NOTE: THE CORRECTED PLAT OF KNODE RANCH SUBDIVISION IS FILED FOR THE PURPOSE OF CORRECTING THE FOLLOWING ERRORS CONTAINED WITHIN THE PREVIOUSLY FILED AND VACATED PLAT.

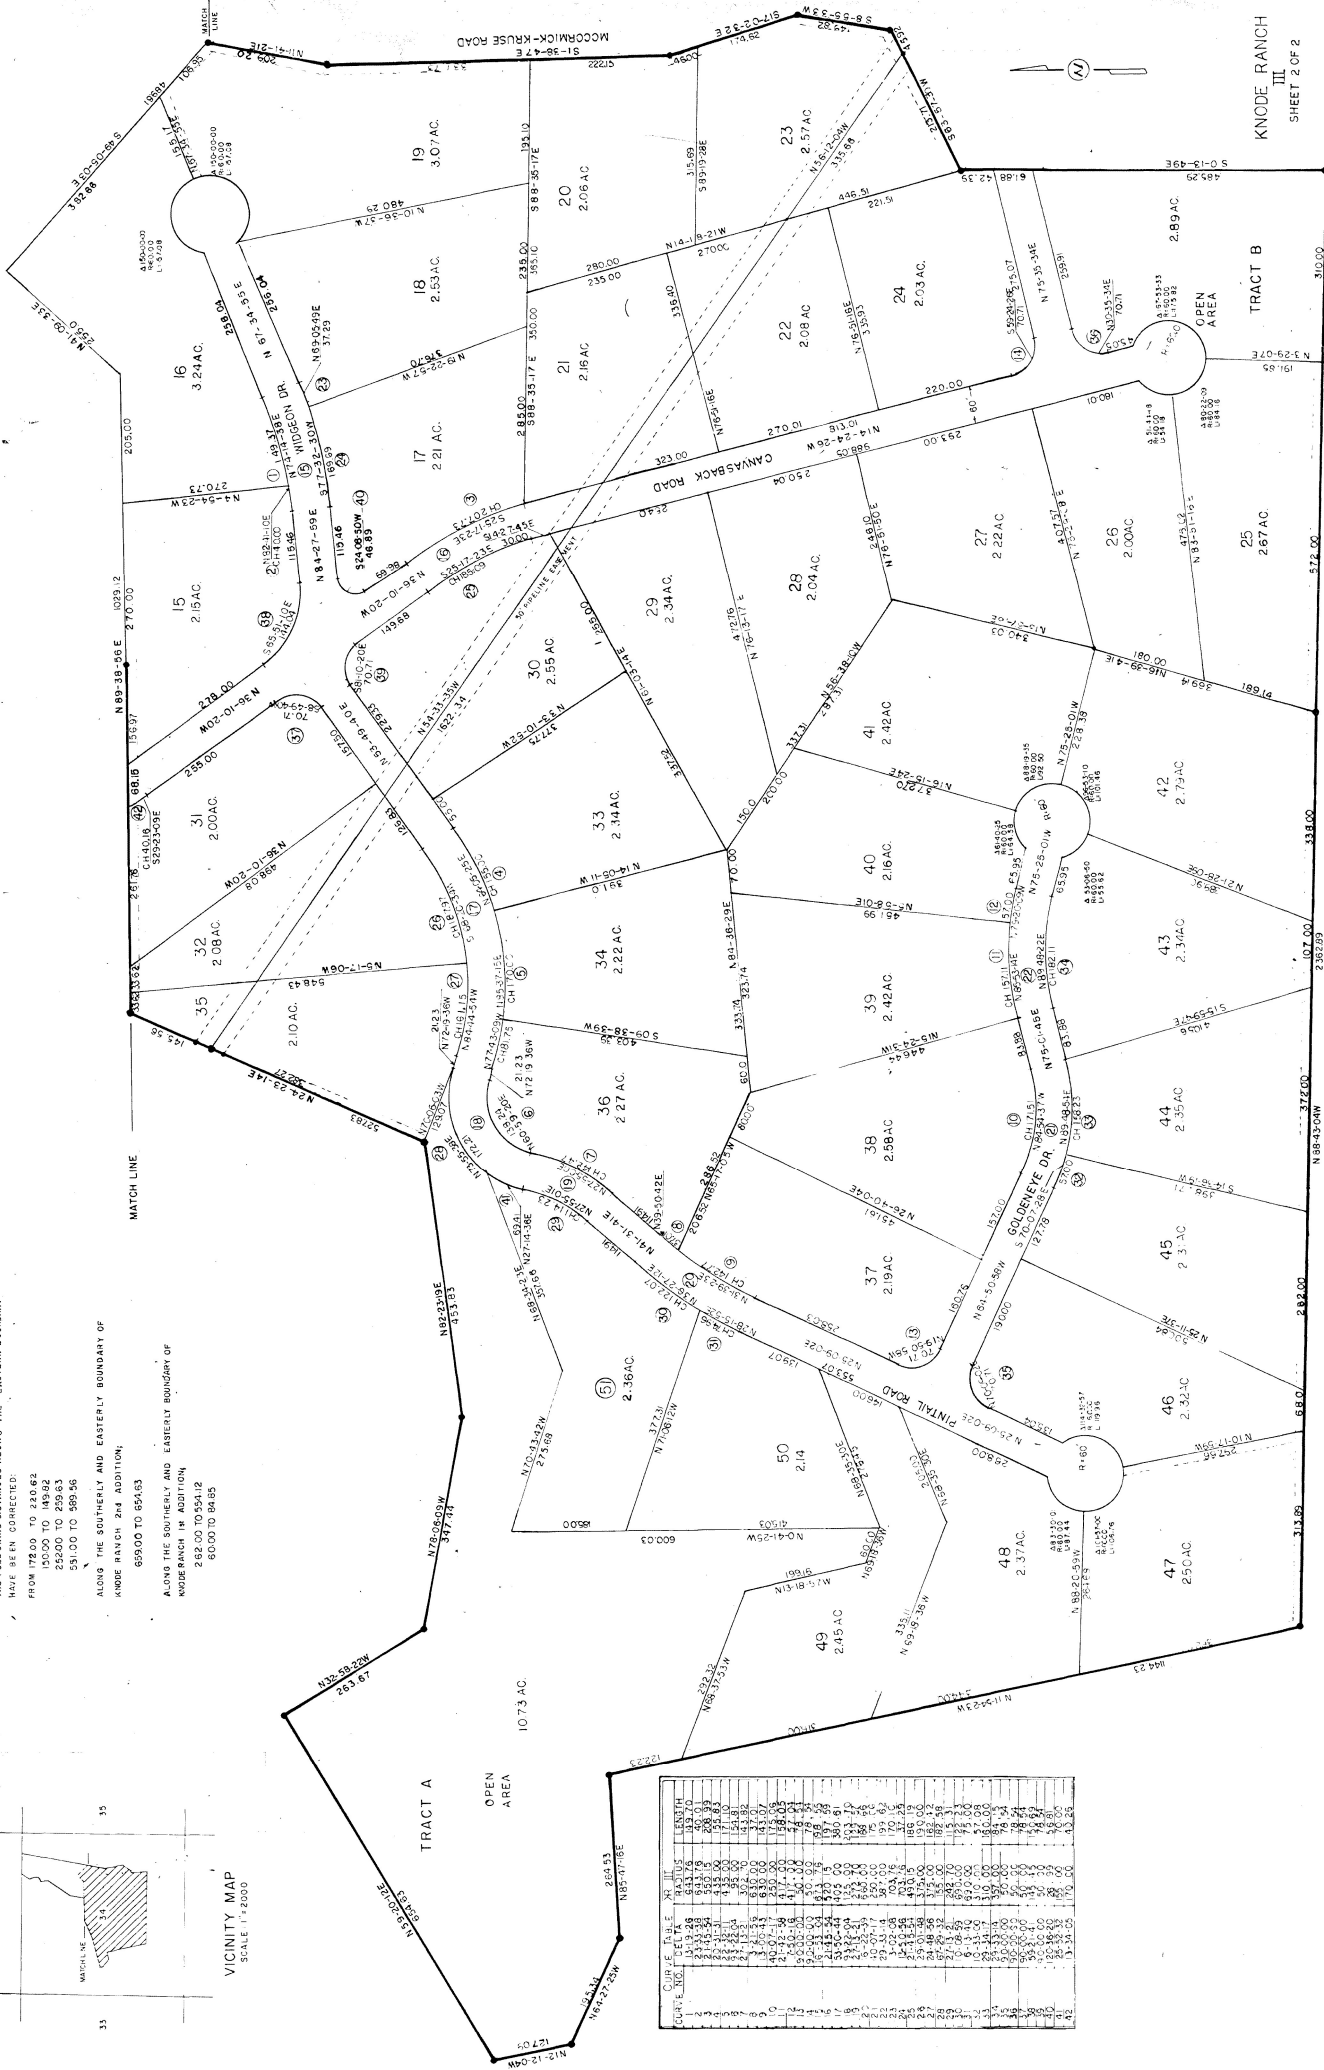
THE FOLLOWING DISTANCES ALONG THE EASTERN BOUNDARY HAVE BEEN CORRECTED:
FROM 172.00 TO 230.62
150.00 TO 149.62
250.00 TO 259.63
551.00 TO 599.56

ALONG THE SOUTHERLY AND EASTERLY BOUNDARY OF KNODE RANCH #24 ADDITION;
695.00 TO 654.63
ALONG THE SOUTHERLY AND EASTERLY BOUNDARY OF KNODE RANCH #25 ADDITION;
263.00 TO 254.12
600.00 TO 645.65
